**BC Timber Sales
Albreda 2015
Visual Assessment and Recommendation
RDI Resource Design Inc**

Blocks Investigated November 19, 2015 (update):

Notes for Current Proposal Assessment 151119

Current Proposal - Viewpoint 1734 - 151119 - Snowmobile Area Percent Alteration

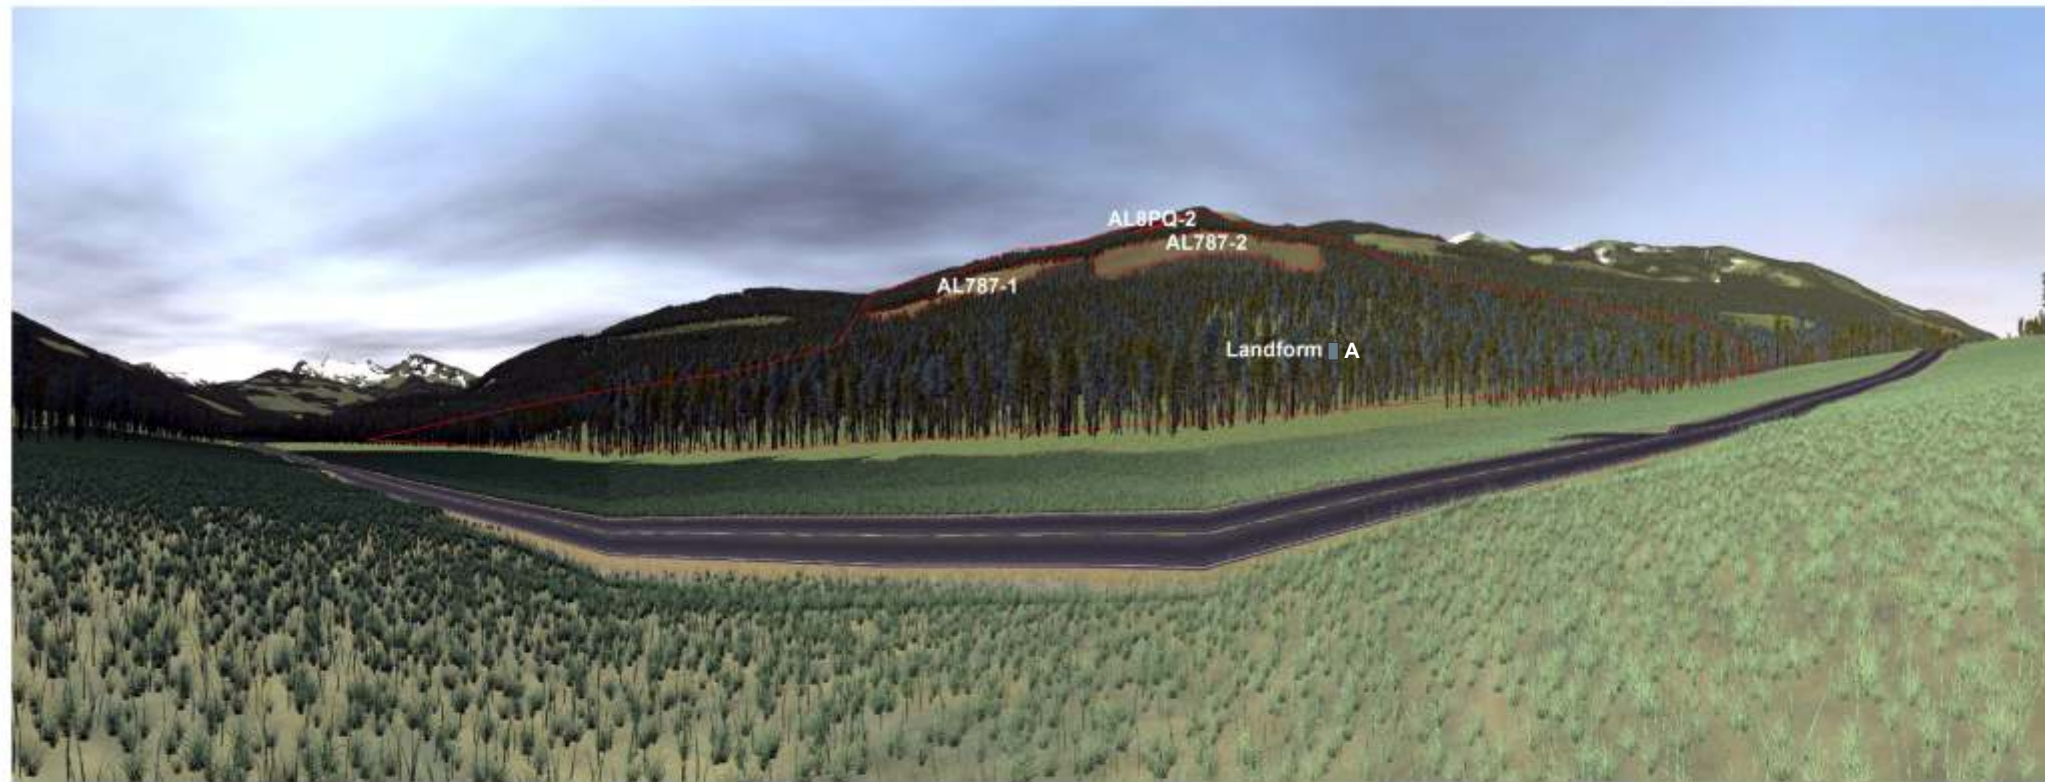
Name	Area_Pers	%Alt
Landform A	849082.97	
AL787-1	12692.35	1.49%
AL787-2	27208.49	3.20%
AL8PQ-1	194.92	0.02%
AL8PQ-2	259.57	0.03%
Sum Alt	40355.32	4.75%

Current Proposal - Viewpoint 1733 - 151119 - Percent Alteration

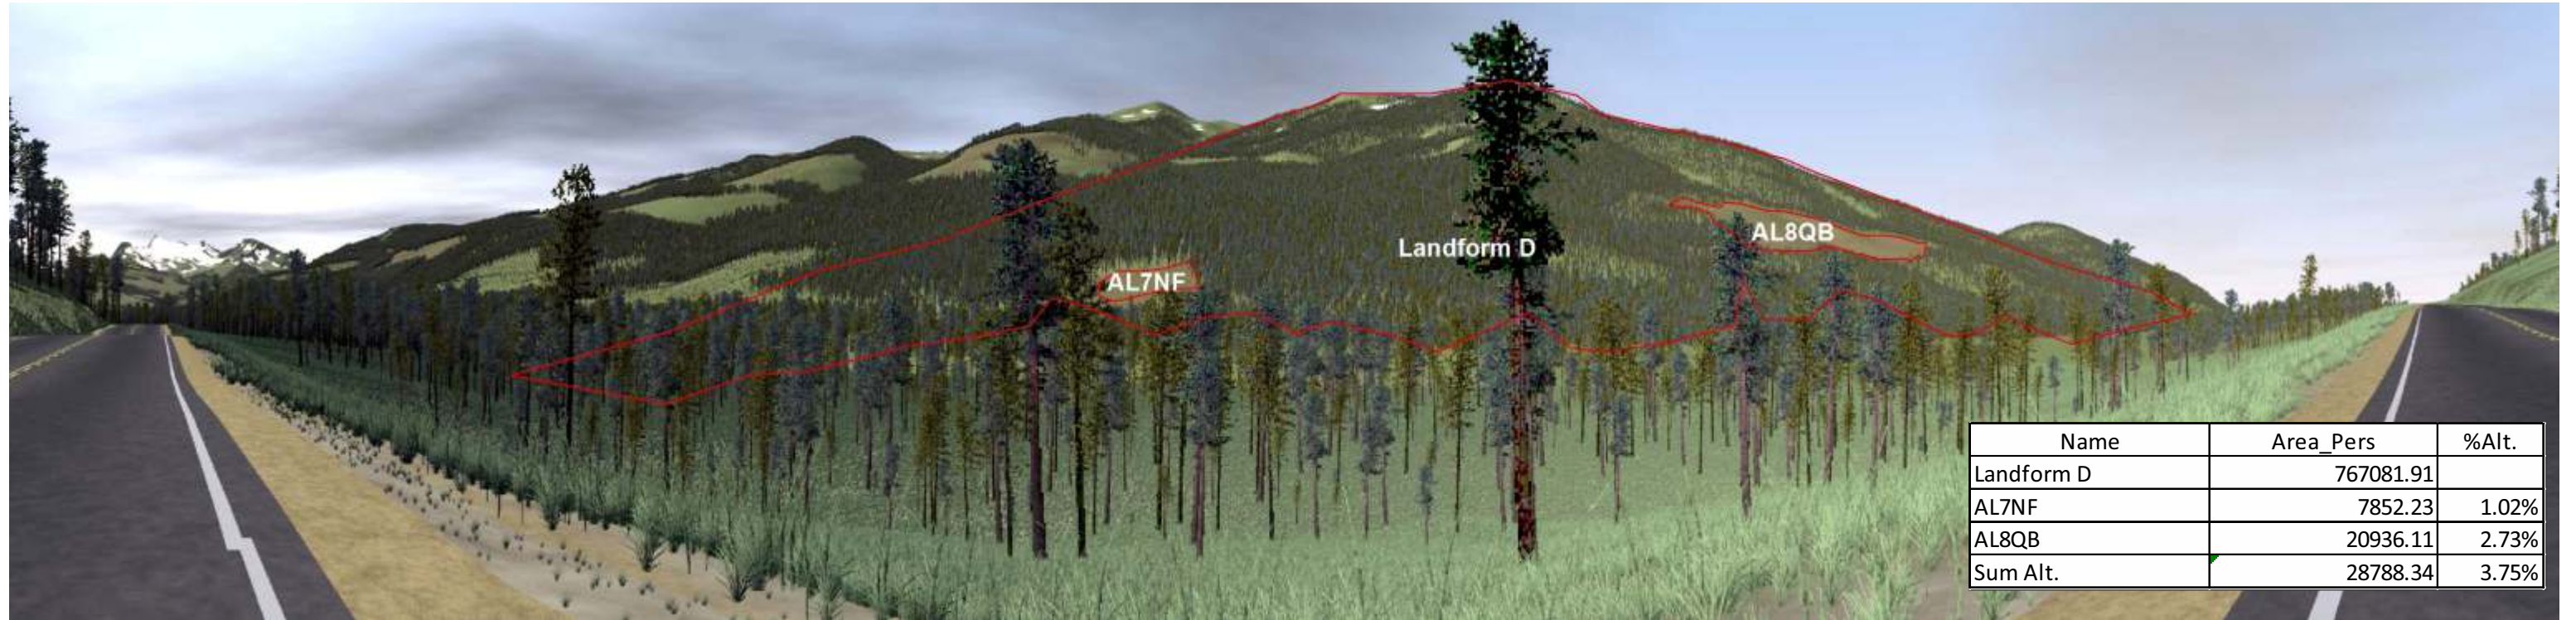
Name	Area_Pers	%Alt.
Landform D	767081.91	
AL7NF	7852.23	1.02%
AL8QB	20936.11	2.73%
Sum Alt.	28788.34	3.75%
